**Re: Horizontal Directional Drill Reevaluation Report
Enhanced Alternative Crossing 5 Discussion
Loyalhanna Lake Crossing (HDD No. S2-0010)
Permit No. E65-973
Loyalhanna Township, Westmoreland County**

Enhanced Alternative Crossing 5
Loyalhanna Lake Crossing (HDD No. S2-0010-16)
PADEP SECTION 105 PERMIT NO. E65-973
PA-WM2-0064.0000-WX-16

Exhibit 2. Land Parcels Traversed by, and Private Water Wells (PaGWIS) Located within 450 Feet of, Alternative 5, Westmoreland County, PA

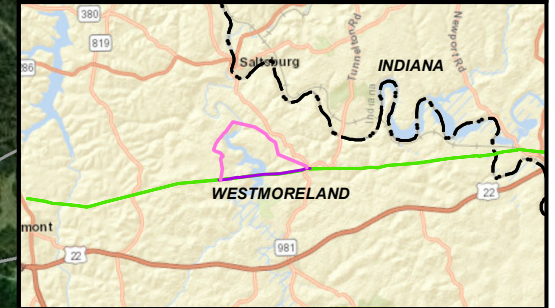
1. Provide information related to property owners that will potentially be affected by the reroute. This information should include identification of all property owners, property boundaries, and location of any public and private water supply sources.

SPLP has identified all property owners and property boundaries that would be potentially affected by the Alternative 5 route. Exhibit 1 presents a table listing all affected property owners and Exhibit 2 presents a figure depicting the boundaries of the associated properties. As identified in the table and figure, the Alternative 5 route traverses a total of 60 individual land parcels (tracts) inclusive of 45 individual private landowners (not including public road crossings), of which 56 tracts and 41 individual private landowners would be newly affected by the Pennsylvania Pipeline Project (PPP).

The Pennsylvania Department of Conservation and Natural Resource's PaGWIS water well data was queried to identify private water wells within 450 feet of Alternative 5. As of August 26, 2019, six (6) private water wells were identified within 450 feet of the centerline of Alternative 5. Exhibit 2 contains a figure depicting the PaGWIS water well locations within the 450-foot-wide buffer zone (as well as in the vicinity of) Alternative 5. The PaGWIS system is a helpful tool when identifying private water wells; however, previous queries of the PaGWIS data have proven to be less comprehensive than actual inquiry with the landowners. Accordingly, it is likely that additional water wells within 450 feet of Alternative 5 would be identified after landowner consultation.

Horizontal Directional Drill (Plan and Profile Drawing) Loyalhanna Lake Alternative 5

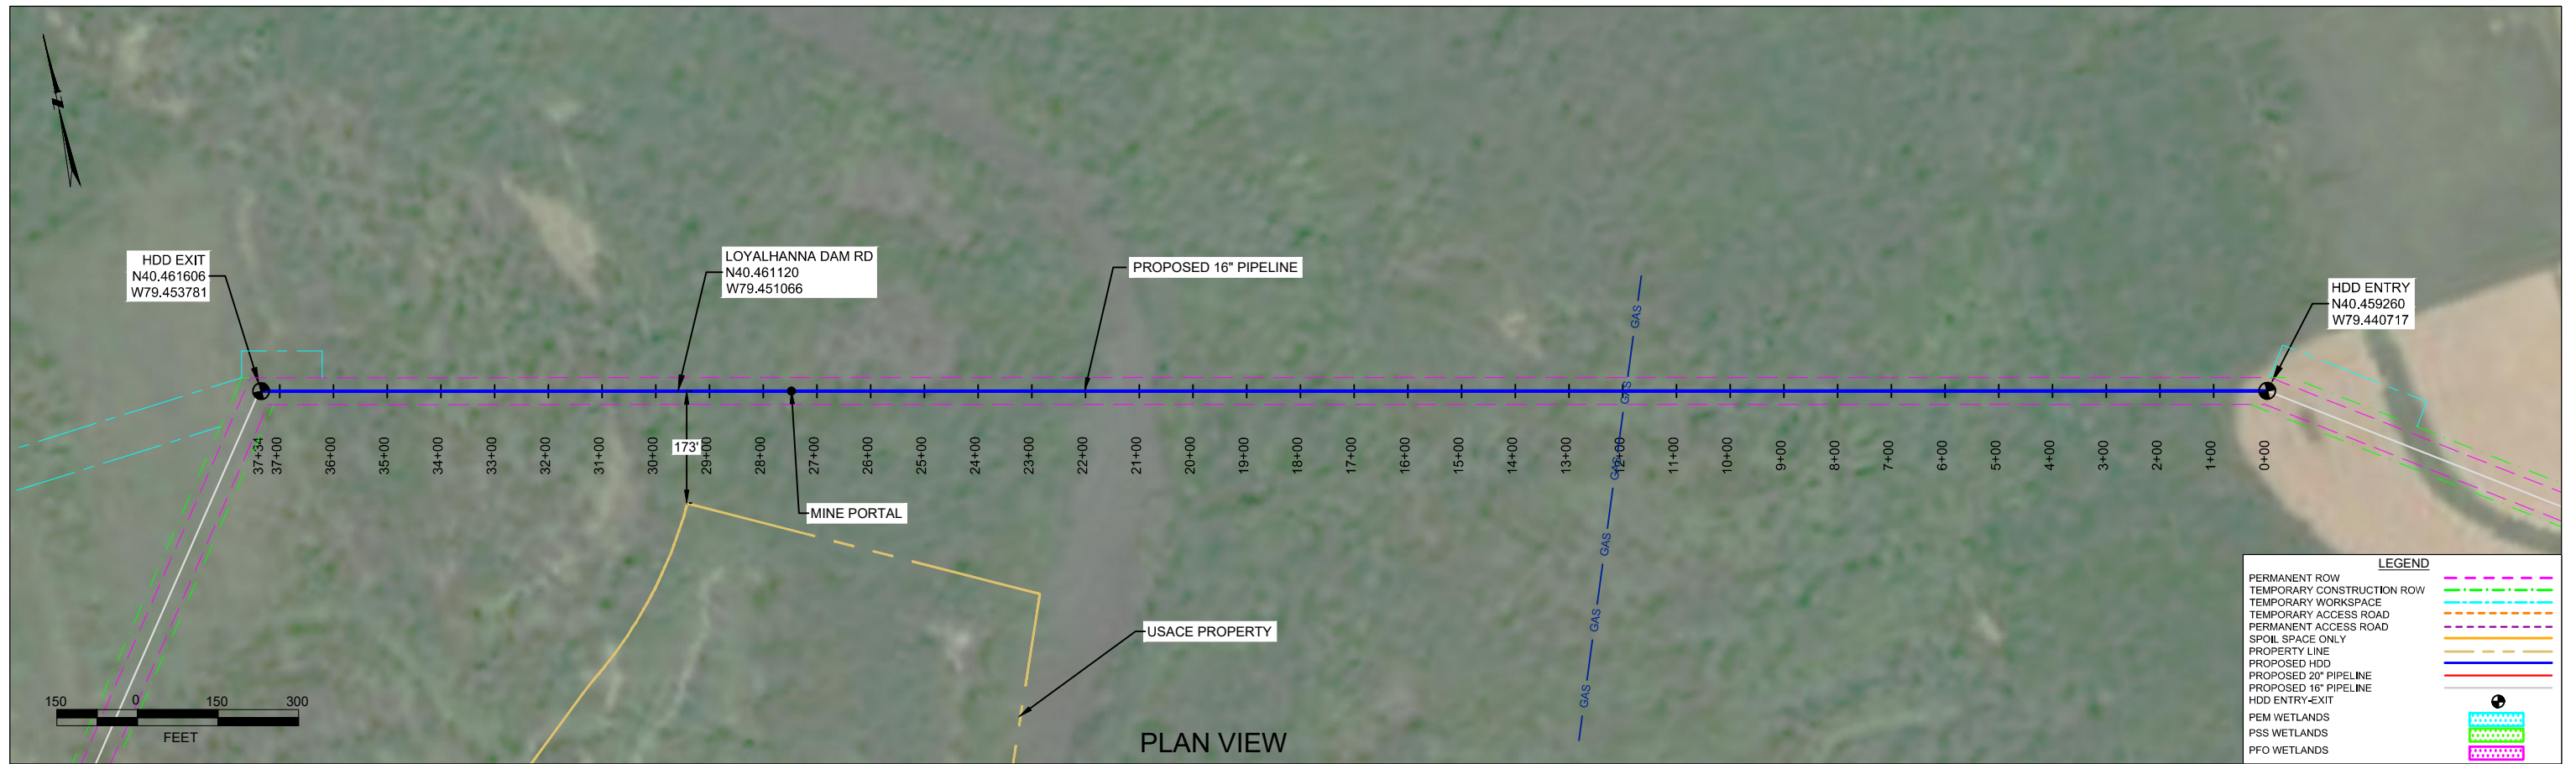
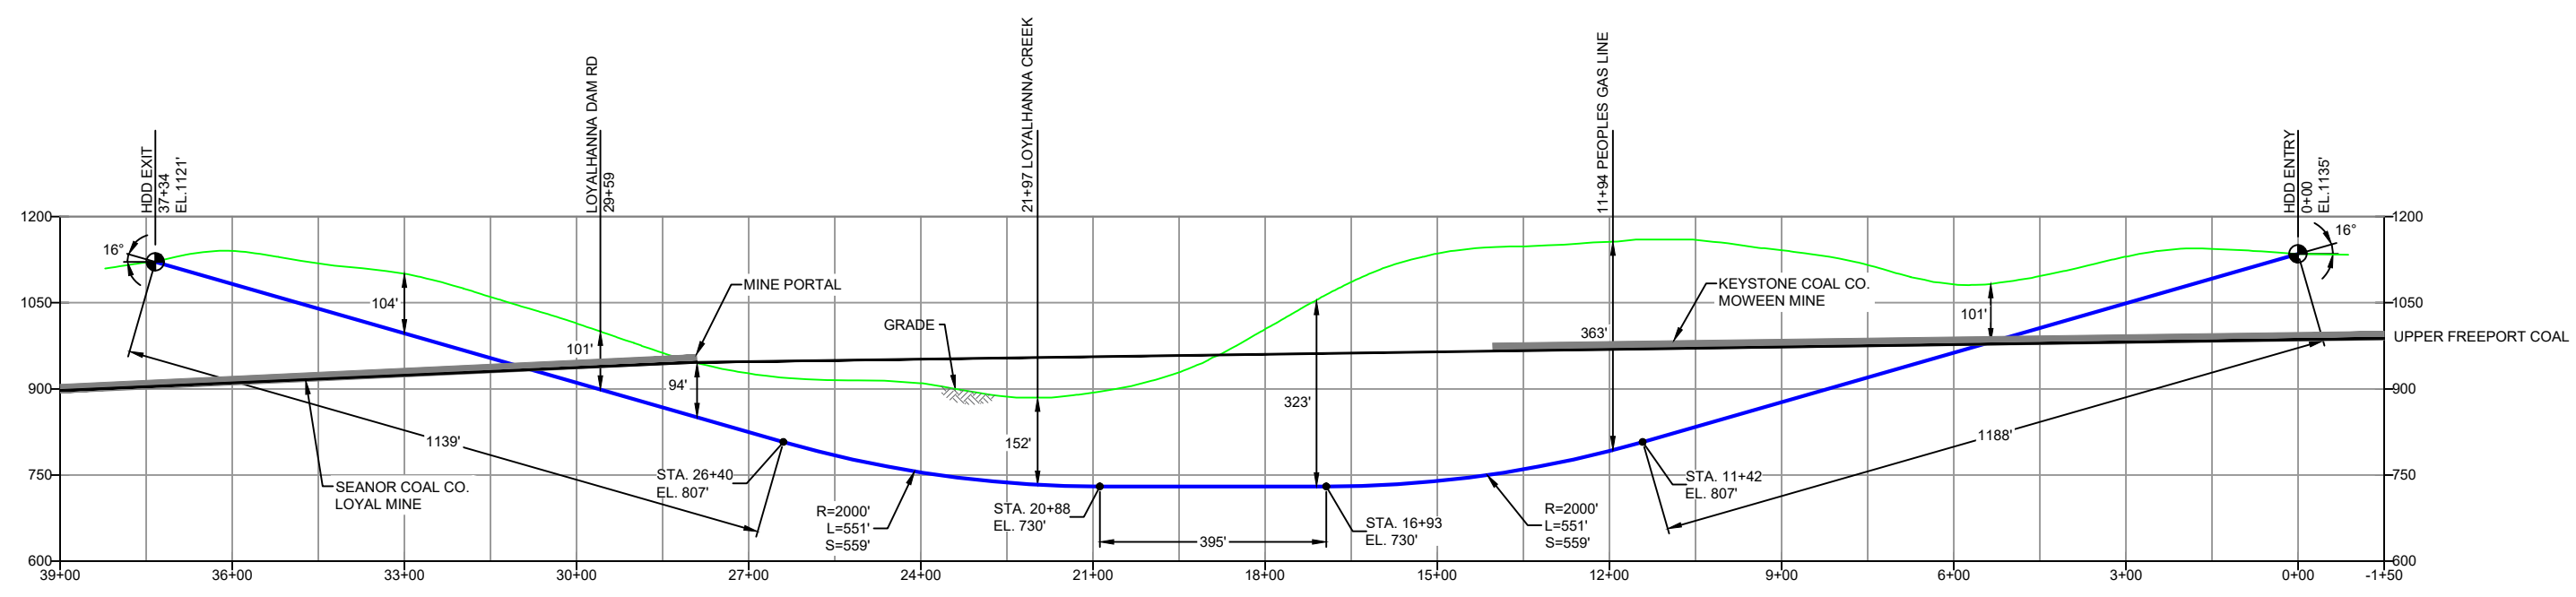
Use of the **HDD construction method** for the approximately 164-foot-long bank to bank crossing of Loyalhanna Creek, via a site-specific designed HDD plan, is **not technically feasible** due to the limitations of this construction technology, as discussed below.

As noted above, as part of SPLP's evaluation of Alternative 5, SPLP performed a more detailed desktop review of the originally-developed Alternative 5 routing alignment presented in SPLP's letter to the Department dated April 11, 2019. As a result of this review, SPLP developed a revised alignment for Alternative 5 that avoids crossing USACE property, Bush Recreation Area, and Loyalhanna Lake. Using this revised alignment, SPLP developed a site-specific HDD construction method plan for the approximately 164-foot-long bank to bank crossing of Loyalhanna Creek. A plan and profile drawing depicting this HDD plan is provided in Exhibit 4.

The subject HDD is aligned with surface topography to accommodate entry and exit workspaces on relatively level terrain, allow a reasonable HDD profile (or pipe radius), and ensure adequate pipe depth (152 feet) below the bed of Loyalhanna Creek to minimize the potential for an inadvertent return of drilling fluids to the creek. The HDD is 3,734 feet in length, and would avoid surface disturbances to Loyalhanna Dam Road, Loyalhanna Creek, and a buried natural gas pipeline. Due to the HDD exit workspace being located at a point of inflection in the revised Alternative 5 alignment, the HDD pullback string workspace would not be aligned with the pipeline right-of-way and thereby would require an approximately 3,700-foot-long temporary workspace located to the west of the HDD exit, which in turn would require substantial clearing of primarily forested land.

However, use of the subject HDD plan is not technically feasible due to the presence and HDD profile intersection of two existing and extensive subsurface (deep mining) coal mines, as depicted in Exhibit 5. Specifically, as depicted in Exhibit 4, the HDD profile intersects the existing Keystone Coal Company's Moween Mine on the east side of Loyalhanna Creek (at approximately 480 feet along the HDD profile and west of the HDD entry) at a depth of approximately 100 feet below ground surface. Also as depicted in Exhibit 4, the HDD profile intersects the existing Seanor Coal Company's Loyal Mine on the west side of Loyalhanna Creek (at approximately 3,079 feet along the HDD profile, and approximately 655 feet east of the HDD exit) at a depth of approximately 100 feet below ground surface; the HDD profile also traverses less than 100 feet below the portal (entrance) of this mine. The HDD profile intersects mined-out intervals of the Upper Freeport Coal seam, meaning the HDD profile would encounter empty space and mine pools

associated with the mined portions of these two deep mines. As the HDD construction method passing through the mines is infeasible without a high probability of significant fluid losses and potential impacts to the mine pool levels, the use of the HDD construction method through these mined intervals is technically infeasible.
